# Town of Brewster Board of Health

## BOARD OF HEALTH MEETING AGENDA

September 20, 2023 at 6:30PM

6. Discuss and vote: 0 Greenland Pond Road M94 L29, new construction with proposed I/A Technology MicroFAST 0.5 General Approval for Nitrogen reduction

Proposed Site & Sewage Disposal System  
 0 Greenland Pond Rd. (Lots 5 & 7), Brewster, MA

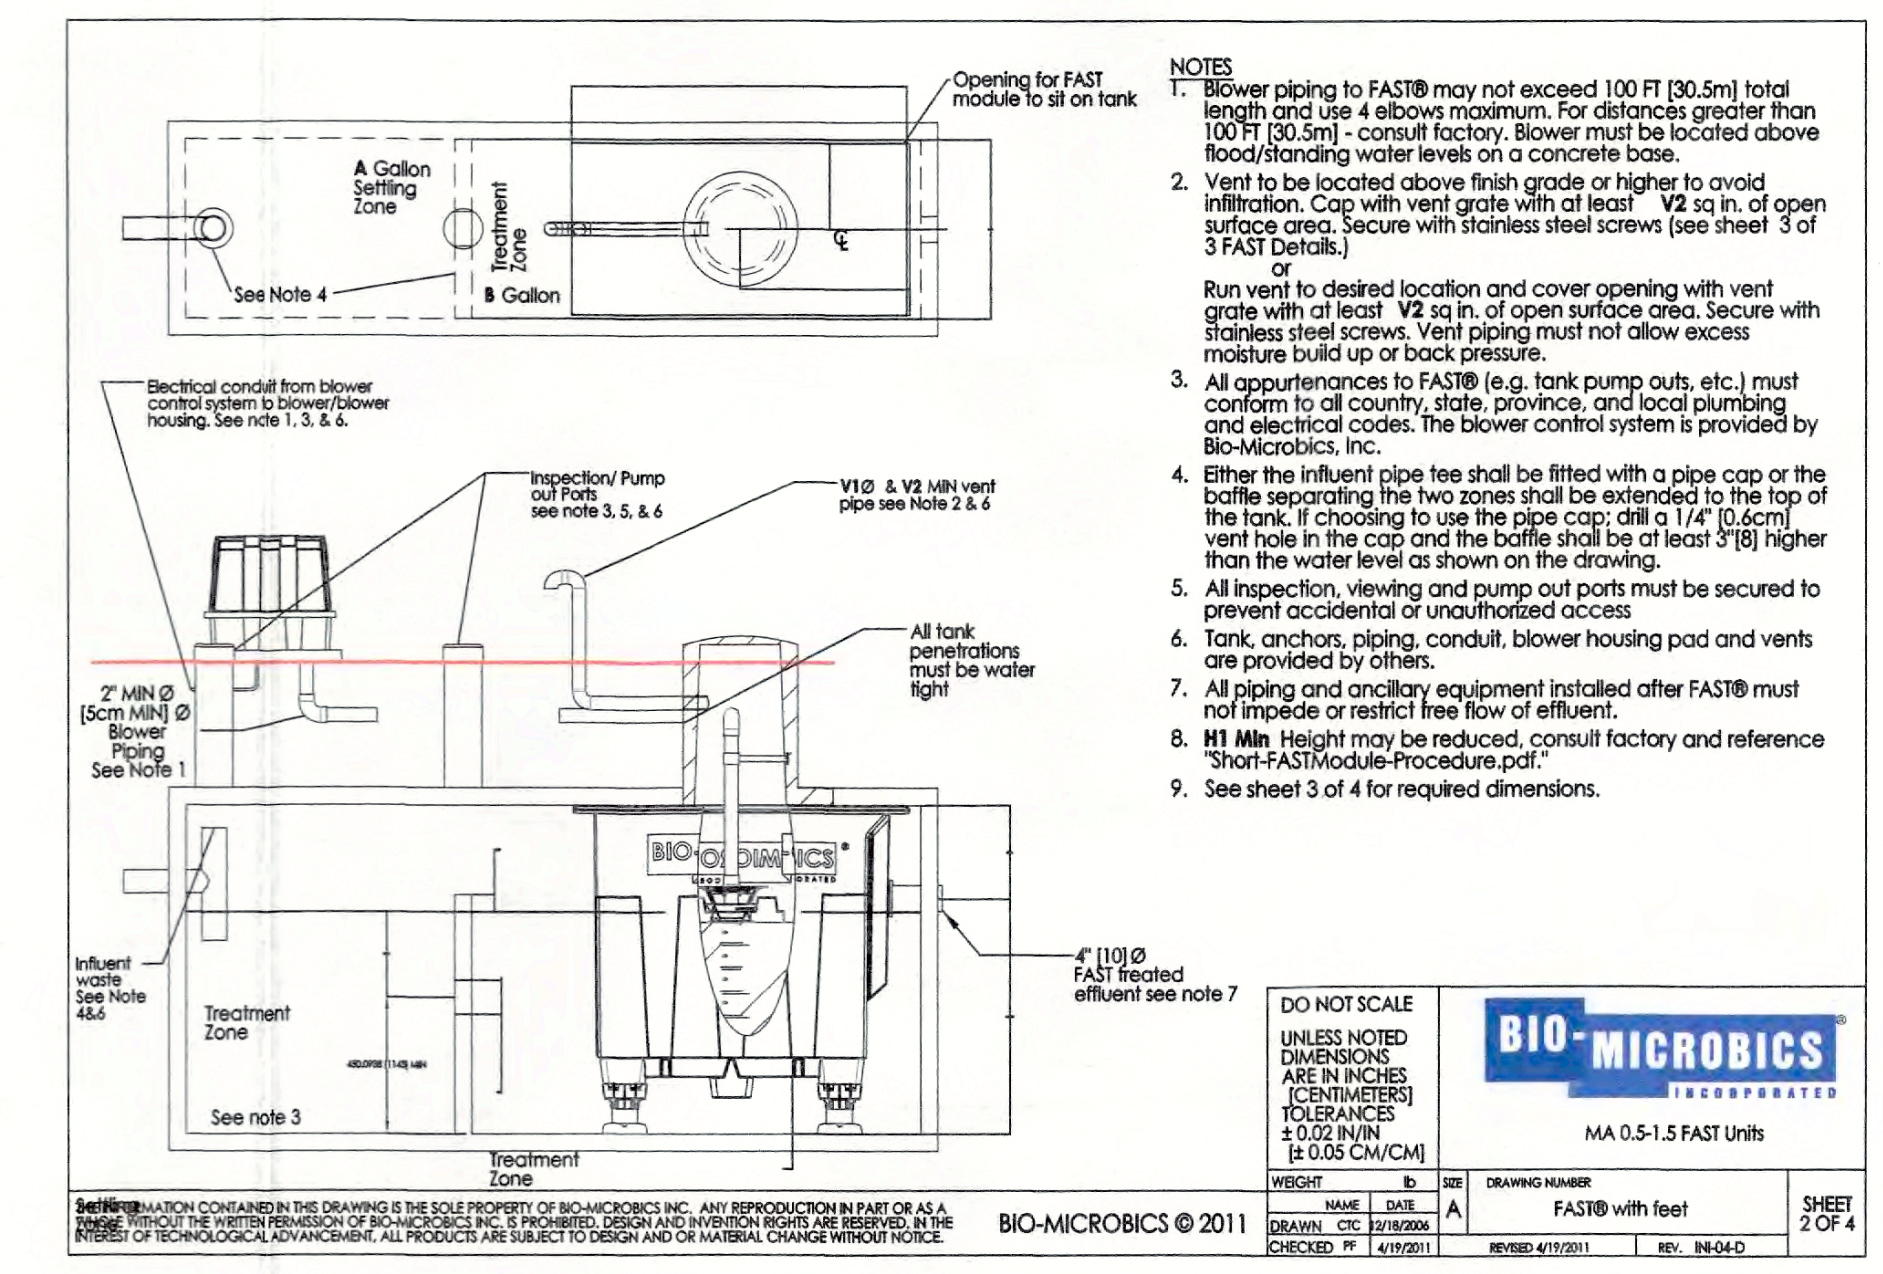
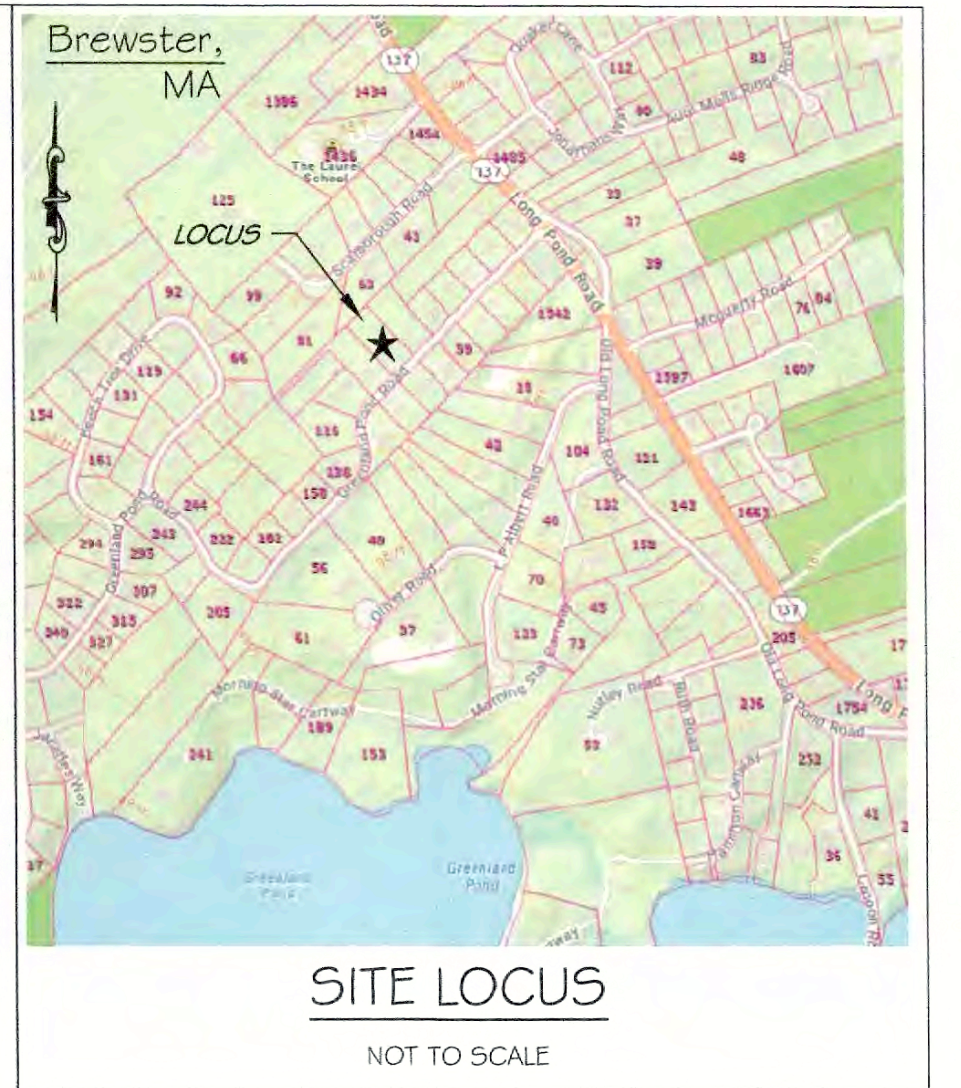
1. The existing vacant lot (Lot 7) consists of 19,489 sf of upland with an abutting lot (Lot 5) of 13,952 sf of upland. The applicant proposes to construct a 3-bedroom single family dwelling with a 4-bedroom capacity Title 5 system and a MicroFAST 0.5 unit for Nitrogen removal.
2. No variances are being requested.
3. Discussion Points:
  - a. The lots are located in a Zone II (Title 5 restriction of 1 bedroom/10,000 sf of land area).
  - b. The lots are located in the District of Critical Planning Concern with a restriction of 5 ppm of Total Nitrogen (more restrictive than Title 5 Zone II).

- c. The lots are located in the Herring River Impaired Embayment Watershed.
- d. Rear abutting lot (Lot 5) – Have Lot 5 and Lot 7 been combined into one lot (81X Plan), otherwise, a nitrogen aggregate plan will be required to utilize the square footage of Lot 5 for calculating the total nitrogen load of the proposed development?

- e. Nitrogen loading calculations indicate 4.44 ppm of Total Nitrogen with a maximum of 4 bedrooms, 3000 sf of lawn area, and the installation of a nitrogen reducing I/A system. Proposed 3000 sf of lawn area should be identified on the site plan as well as the proposed use of the rear lot (i.e., undisturbed natural vegetation).
